# Service Bulletin

Bulletin No.: PIP5810D

**Subject: Transfer Case Input Seal Installation**

5845636

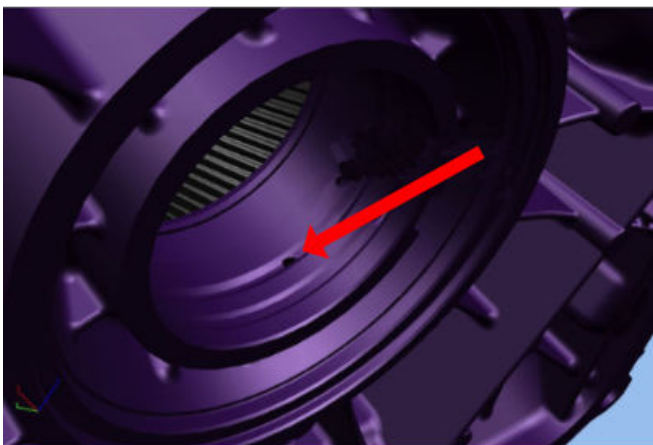
Seal installation depth is critical when replacing the transfer case input seal.

There is a gap around the outer portion of the seal that needs to be centered over a weep hole in the case.

Weep hole is drilled in the center of a groove machined into the case.

5845634

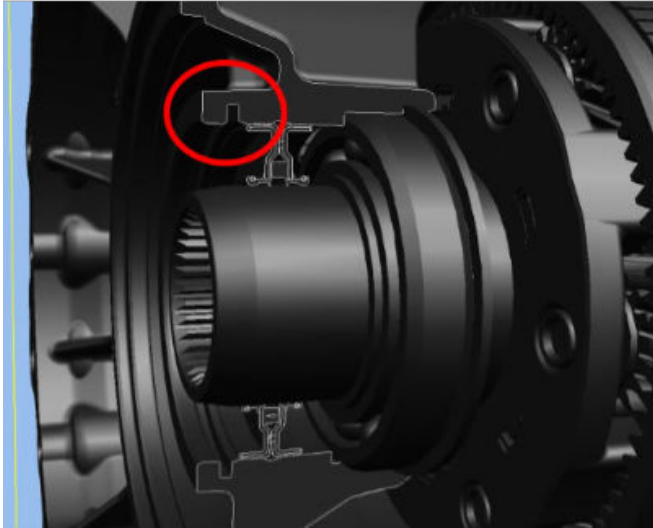
There are 2 design transfer case front case halves and the seals install at different depths between design 1 and 2.

To identify design level look for a machined groove where the seal is installed (Red circles below).

If there is a defined machined groove in the case then it is a first design case.

If there is not a defined groove machined into the case then it is second design.

For first design transfer case see Transfer Case Assemble (VIN LF263576 and Earlier (with MGM or MGU)) in 2020 model year Transfer case off vehicle repair instructions. Seal installer DT-53017 (GM-53017)
